AMENDMENTS TO THE DRAWINGS:

CISCO-3024

FIG. 2

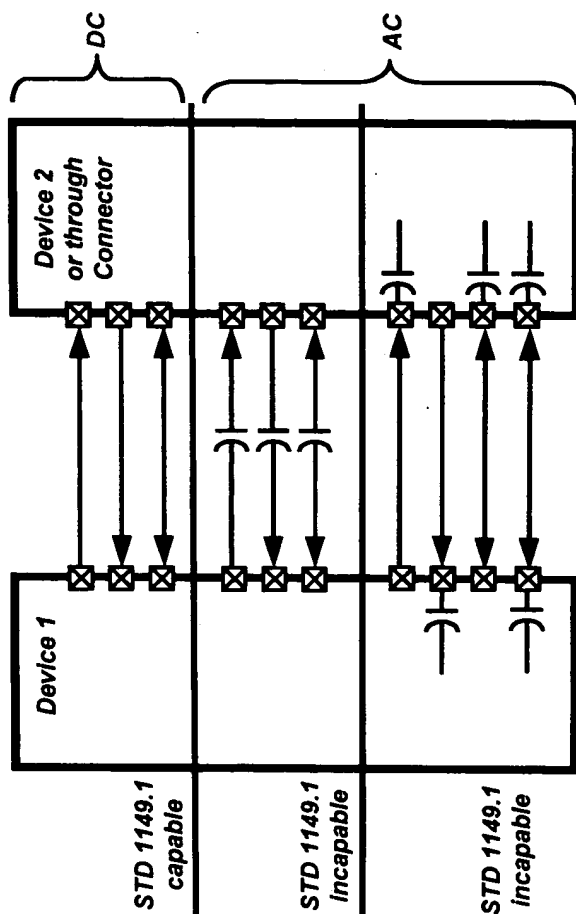
The attached sheets of drawings includes changes to FIGS. 1-3 and 5. These sheets replace the original sheets including FIGS. 1-3 and 5. In FIGS. 1-3, the legend Prior Art has been added. In FIG. 5, the designations of X1 and X2 have been clarified with respect to specification page 16, lines 9-14.

PRIOR ART
